## Heatons and Reddish Area Committee

### DEVELOPMENT APPLICATIONS

<b><u>ITEM 1</u></b>	<b>DC/075339</b>
<b><u>SITE ADDRESS</u></b>	301 Broadstone Road, Heaton Chapel, Stockport, SK4 5HQ
<b><u>PROPOSAL</u></b>	Demolition of existing bungalow and erection of 4 no. dwellinghouses

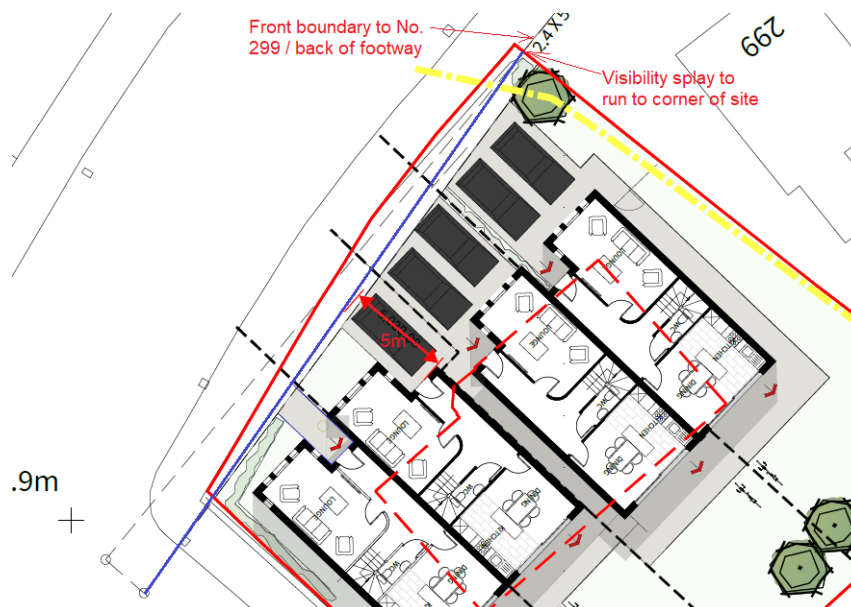
I write with reference to drawing 02-DR-001 Rev B.

I note that the scheme has been amended so as to provide larger rear gardens for the 2 southern semis and amended parking arrangements (with two parking spaces proposed to be provided for the northern two semis and one space proposed for each of the southern two semis).

Whilst I have no objection to the principle of these amendments, the driveway for the second dwelling north of Grange Avenue will not be of quite sufficient length to enable a car to park in it without encroaching onto the visibility splay that will be provided north of Grange Avenue (which, as previously outlined, will need to be formally laid out as a visibility splay by widening the existing footway to include this area). This issue, however, could be addressed by setting back the front door approx. 400mm, as indicated on the drawing below, so as to provide a driveway of a minimum length of 5m (measured from the rear of the visibility splay). A further revised plan is required to deal with this issue.

As outlined above (as well as in the previous highway comments), the visibility splay will need to be formally laid out as a visibility splay by widening the existing footway to include this area. The plan, however, does not show this and therefore, when amending the plan, the visibility splay should be shown as new footway and the cars shown parked in the driveways should be repositioned so that the plan clearly show that cars can park in the driveways without encroaching on the visibility splay. Full details of how the visibility splay will be formed will, however, need to be agreed, although this can be dealt with by condition).

Subject to the receipt of a further revised plan, however, I would consider the amended scheme acceptable.

- Recommendation: No objection, subject to the receipt of a further revised plan and conditions.
